Subject: Work Plan Addendum No. 1 for Follow-up Sample Collection and Testing at the Former Mill A Marine Area, Everett, Washington

This memorandum has been prepared as an addendum to the Remedial Investigation/Feasibility Study (RI/FS) Work Plan and Marine Area Sampling and Analysis Plan (SAP) for the Former Mill A Site (Site) (GeoEngineers 2014a). This addendum is being provided on behalf of the Port of Everett and Weyerhaeuser Company and describes additional sample collection for chemical and bioassay testing at the Site. This addendum has been prepared to supplement and meet the RI requirements specified in the Work Plan.

Figure 1

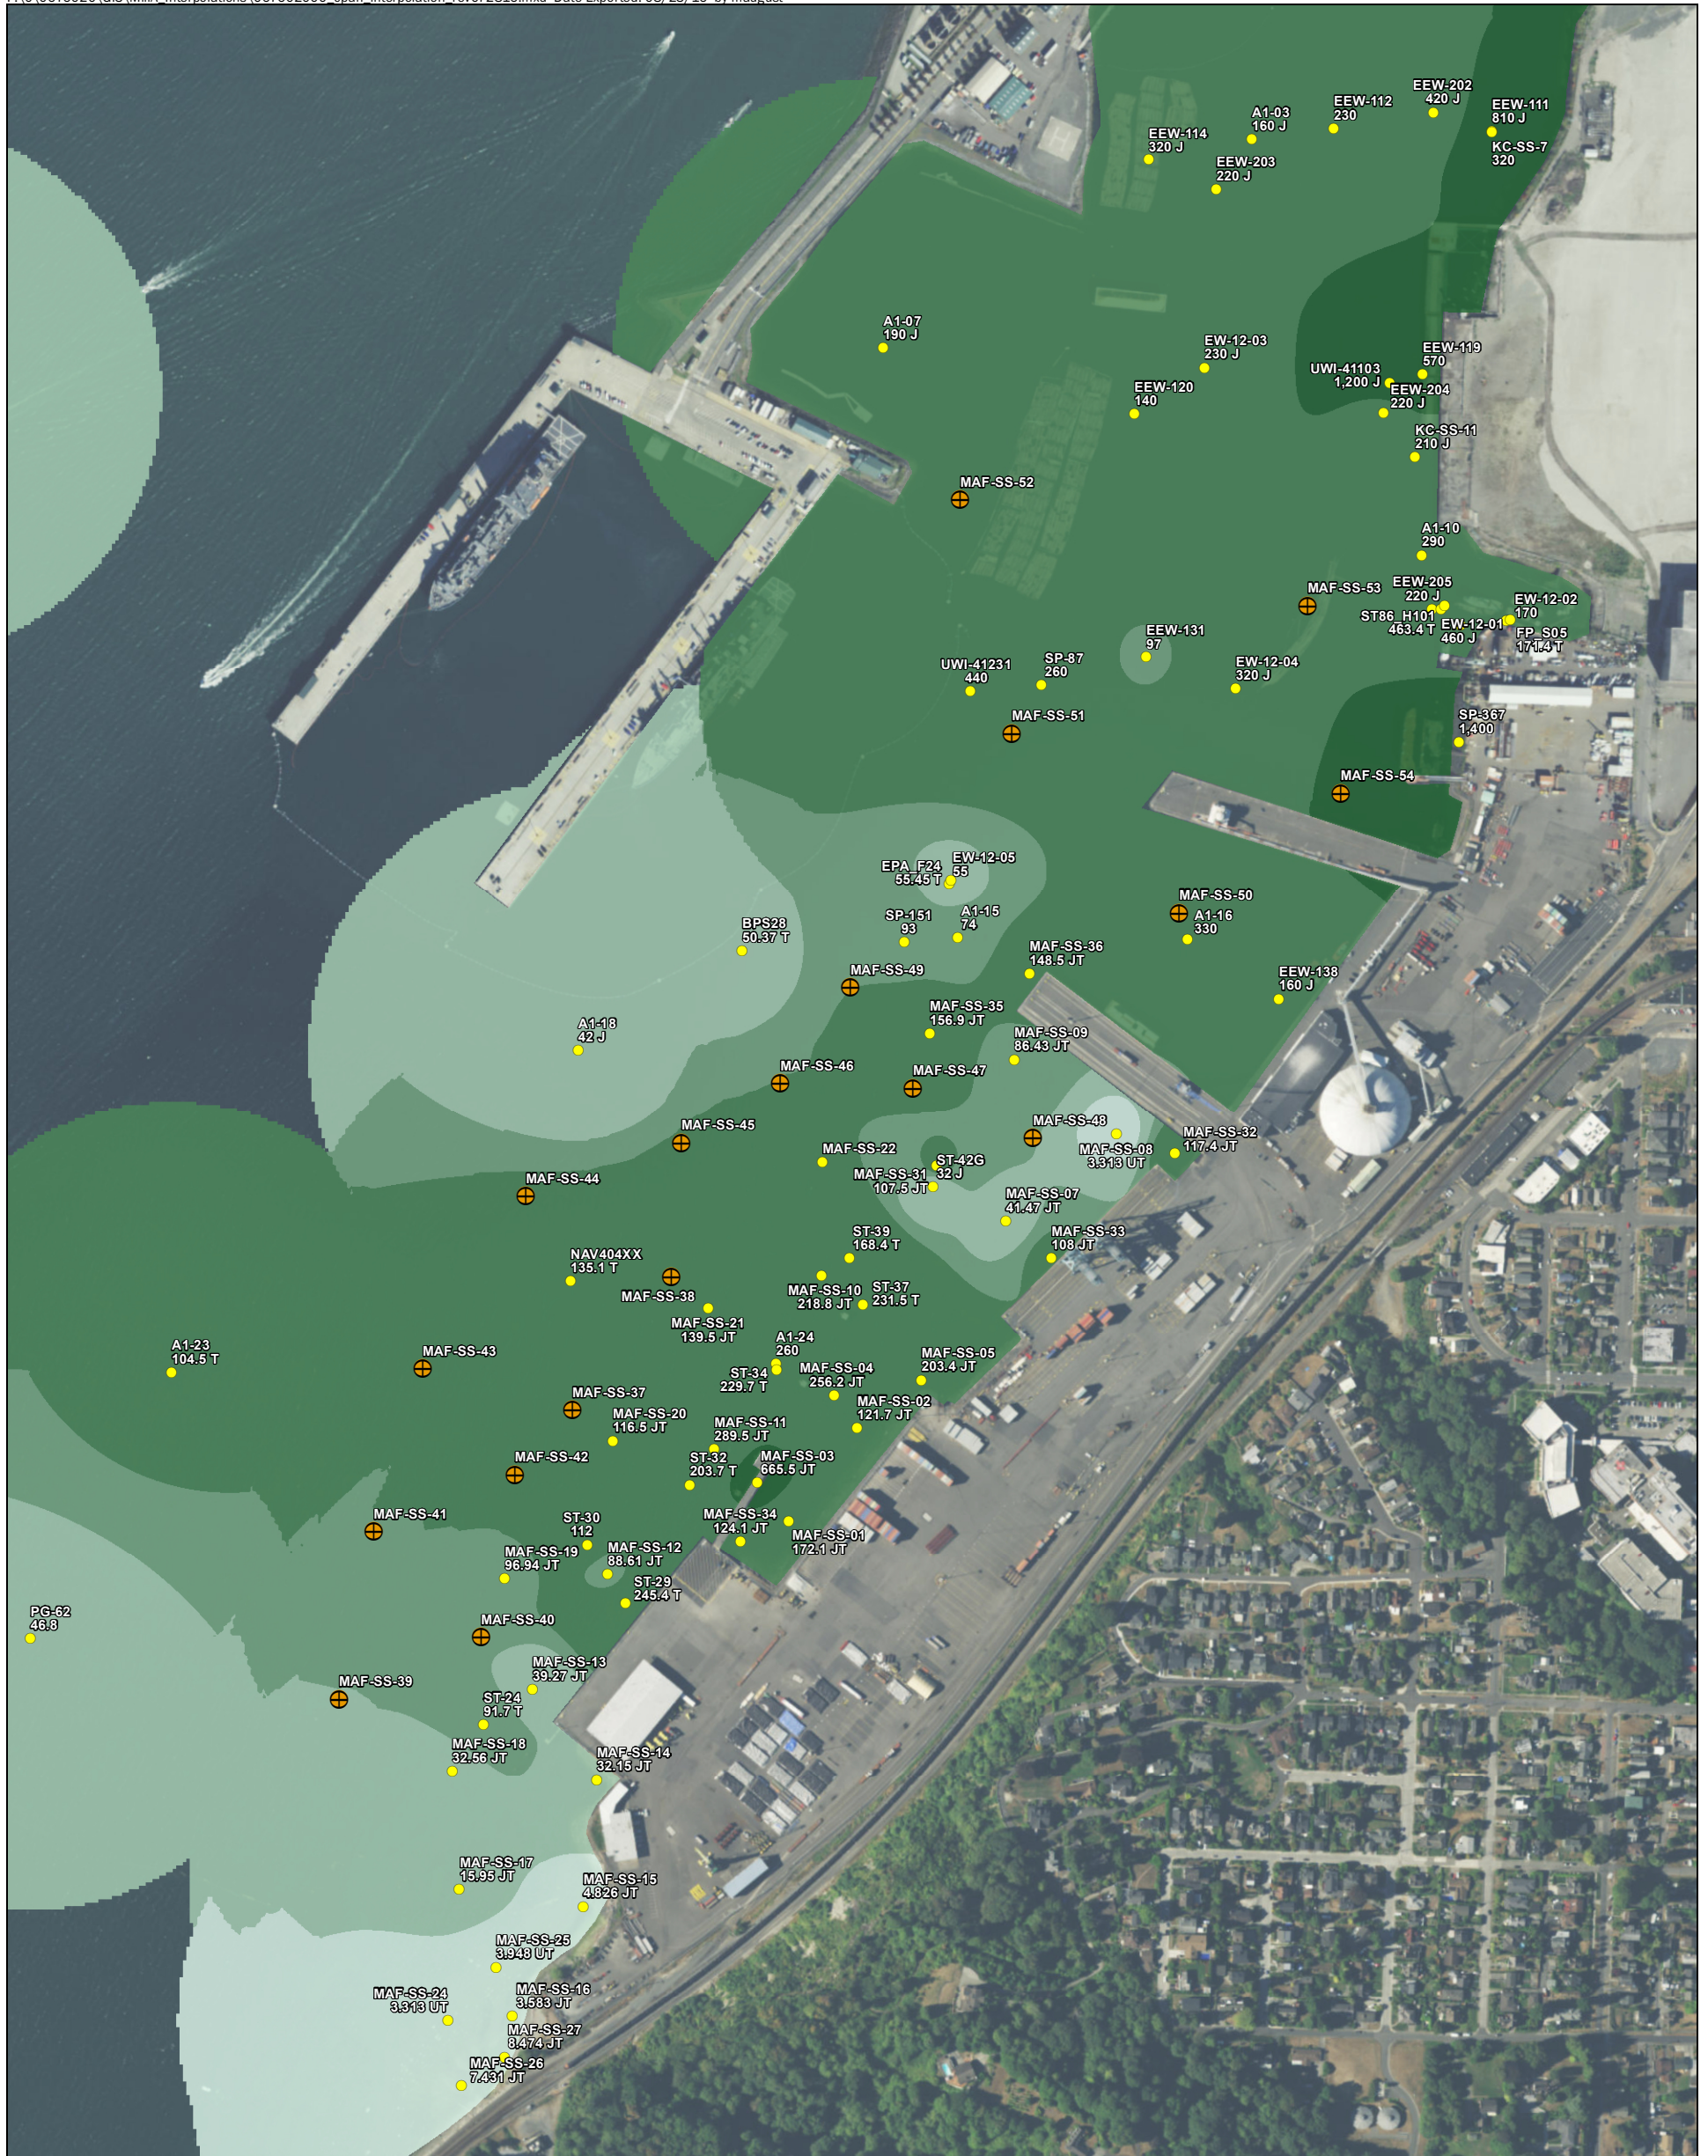
Figure 1 identifies the proposed bioassay testing locations and Table 2 provides coordinates for each sampling location and a description.

At the request of Ecology, two new surface sediment locations will be sampled (MAF-SS-37 and MAF-SS-38) northwest of MAF-SS-20 and MAF-SS-21 to further evaluate the extent of potential benthic community impacts. The two new sample locations are shown on Figure 1. These samples will be analyzed for conventional parameters and the chemical analytes that were exceeding the SMS criteria in sediment from adjacent sample locations MAF-SS-20 and MAF-SS-21. The conventional and chemical analyses will include the following:
